## **ABBREVIATED PLAT AGENDA**

STAFF REVIEW AND RECOMMENDATIONS  
PUBLIC HEARING  
JUNE 14, 2023

ABBREVIATED PLAT: BREEZY MEADOWS

REVIEWED BY: CHRIS CURLIN CASE #: 2023-060

For Map: 1840  
Scale: 1"=80'  
Drawn: R/C/Checked: JZ  
By: Page:  
Date: 4/27/23  
MSB Case No.: N/A  
SHEET: 1 of 1

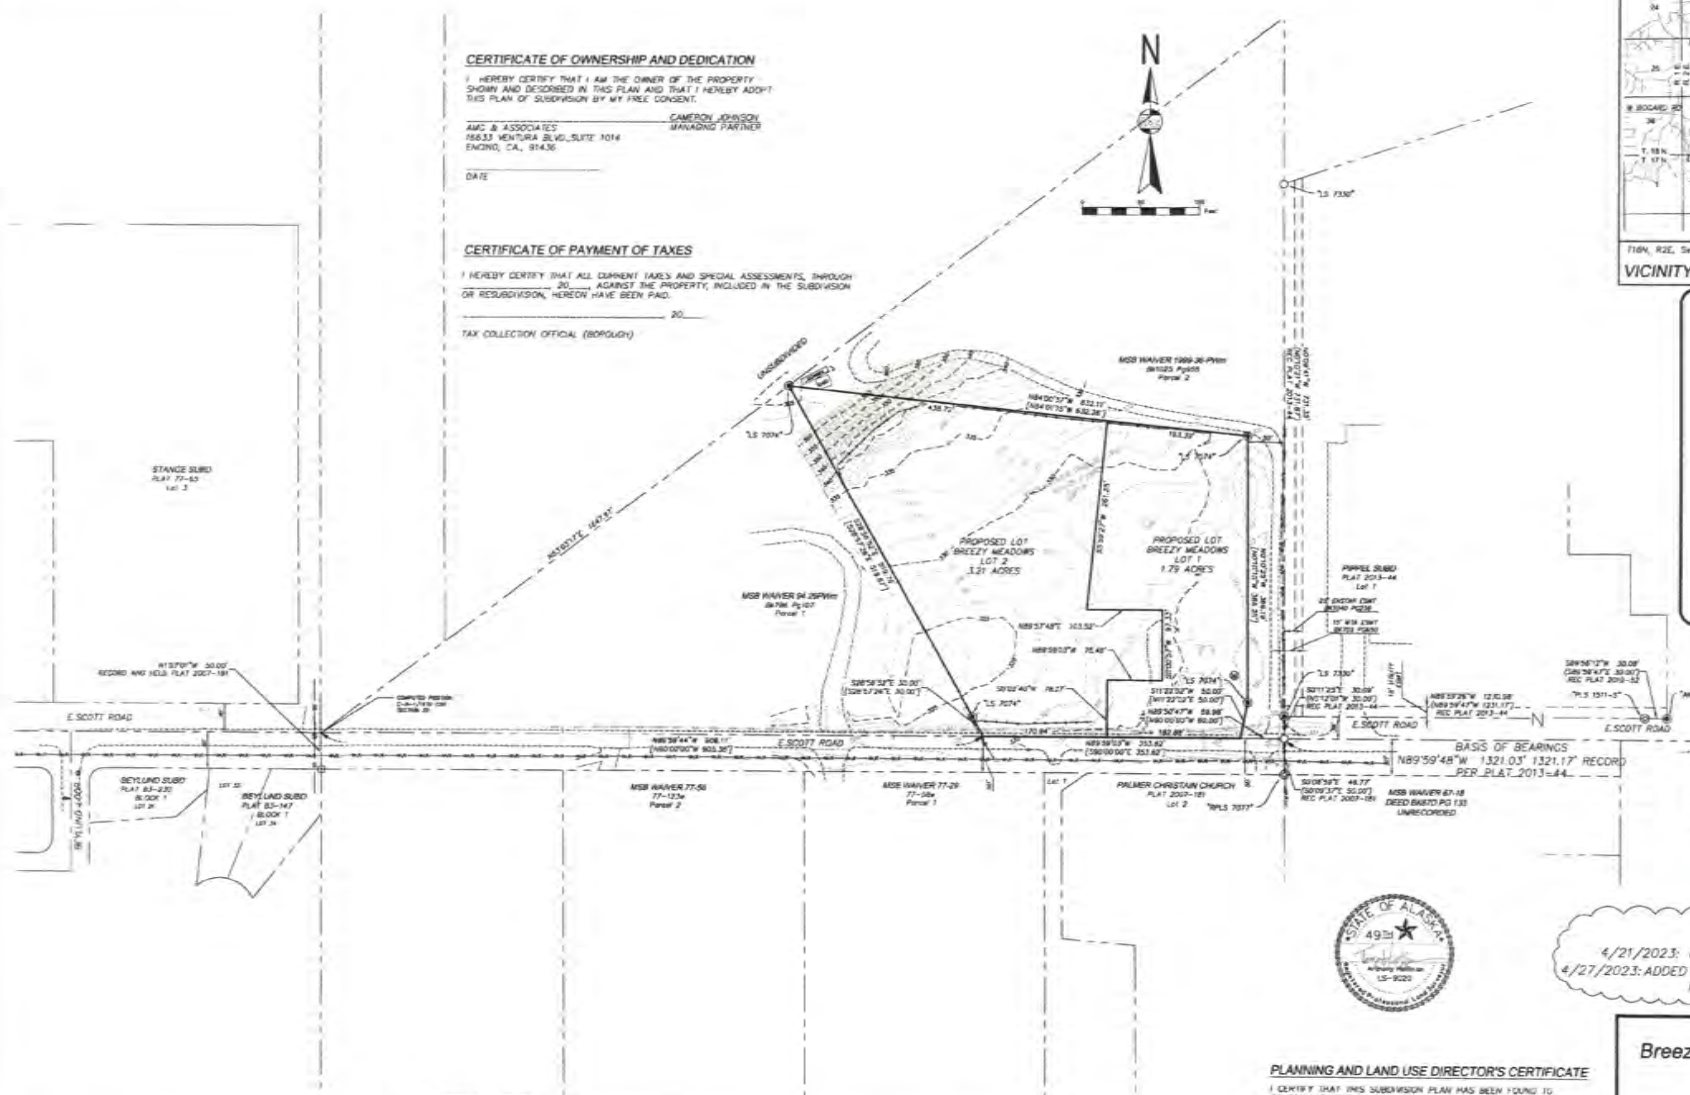
**Comments:** Department of Public Works Pre-Design Division (**Exhibit C**) notes both lots should share a common access unless otherwise approved by AKDOT&PF.

ADOT&PF: (**Exhibit D**) Has no objection to proposed lot subdivision, requests a 50' right of way dedication, and states that ADOT&PF will permit consolidated shared access between two lots. ADOT&PF requests a plat note stating, "Subsequent subdivision of lots will require continued use of shared access and utilities.

City of Palmer Fire Chief attached a separate letter **(Exhibit G)** to City of Palmer's response stating there should be two separate and approved fire apparatus access roads or all dwelling units are to be equipped throughout with an approved automatic sprinkler system and the number of dwelling units on a single fire apparatus access road shall not be increased unless fire apparatus access roads will connect with future development, as determined by the fire code official. Fire chief is satisfied with roadway width, so long as the roadway is capable of supporting a load of fire apparatus weighing at least 75,000 pounds.

**Utilities: (Exhibit H)** GCI has no comments. Enstar has no comments or recommendations. MTA requests a 15' utility easement in the south 15' of proposed lots 1 & 2. MEA did not respond. *Platting staff notes that utility easements cannot be granted on an abbreviated plat.*

I am satisfied with the roadway width presented in your Breezy Meadows Site Plan, so long as the roadway is capable of supporting a load of fire apparatus weighing at least 75,000 pounds.

The supplied Breezy Meadows Site Plan shows ten, four-unit complexes in Phase 1 and Phase 2. Per 2012 International Fire Code (IFC), Appendix D, Section D107.1 there must be two separate and approved fire apparatus access roads.

Either your site plan must show two separate and approved fire apparatus access roads or you need to equip all dwelling units with an approved automatic sprinkler system in accordance with the IFC. I have provided the relevant IFC section below for your reference. The State of Alaska Fire Marshal's Office will be able to approve any and all automatic sprinkler systems in your building permit process.
